Access Compliance Report

Public Rights-of-Way

Intersection ID: 46811	Main Street: ARBOR_VISTA_DR	Cross Street: ROSE_CREEK_CT	Location: E
ADA ID: E1BD0C15B1E8	Ramp Type: PerpDiag	Initial Pass/Fail: Pass	Overall Compliance: No
		Severity Score: 21.5

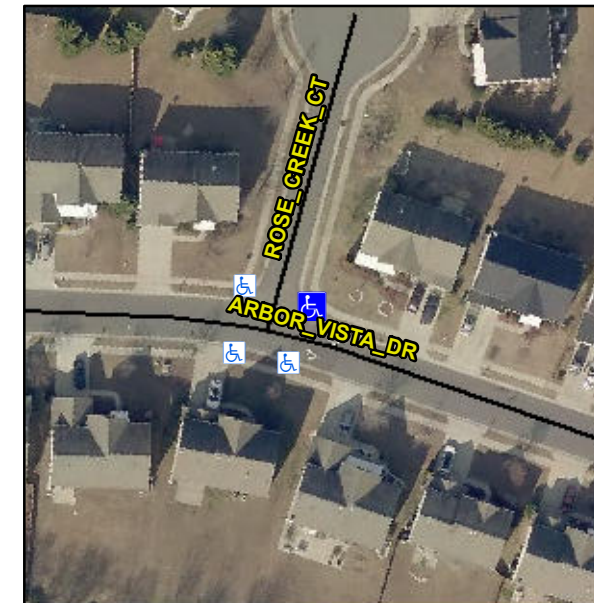
Not Found, R304.2.1, R304.5.3, R305, R302.7.2

Compliance	Description	Data	Compliance	Description	Data
N/A	Ramp Length (in)	49.0	Yes	Ramp Slope (%)	6.2
Yes	Ramp Width (in)	50.0	Yes	Ramp XSlope (%)	1.3
N/A	Flare Type LT	Sloped	N/A	Flare Type RT	N/A
N/A	Flare Slope LT (%)	9.6	N/A	Flare Slope RT (%)	1.8
N/A	Flare Traversable LT?	No	N/A	Flare Traversable RT?	No
No	Landing Length (in)	46.0	No	DWS Provided?	No
No	Landing Width (in)	42.0	N/A	DWS Contrast?	No
Yes	Landing Slope (%)	1.3	N/A	DWS Length (in)	N/A
No	Landing X Slope (%)	4.1	N/A	DWS Full Width?	No
N/A	Landing Curb? (Y/N)	No	N/A	DWS Offset (in)	N/A
N/A	Shared Landing?	No			
Yes	Gutter Ponding?	No	Yes	Gutter Slope (%)	3.2
No	Gutter Lip Ht (in)	0.5	No	Gutter X Slope (%)	2.3
N/A	Painted X Walk1?	No	N/A	Painted X Walk2?	No
	X Walk 1 Direction	To NW		X Walk 2 Direction	To SW
N/A	X Walk 1 Width (in)	N/A	N/A	X Walk 2 Width (in)	N/A
	X Walk 1 Slope (%)	2.0		X Walk 2 Slope (%)	1.6
	X Walk 1 X Slope (%)	1.8		X Walk 2 X Slope (%)	0.9

Remove & Replace Curb Ramp With Two New Directional Ramps or Equivalent. Remove & Replace Gutter.
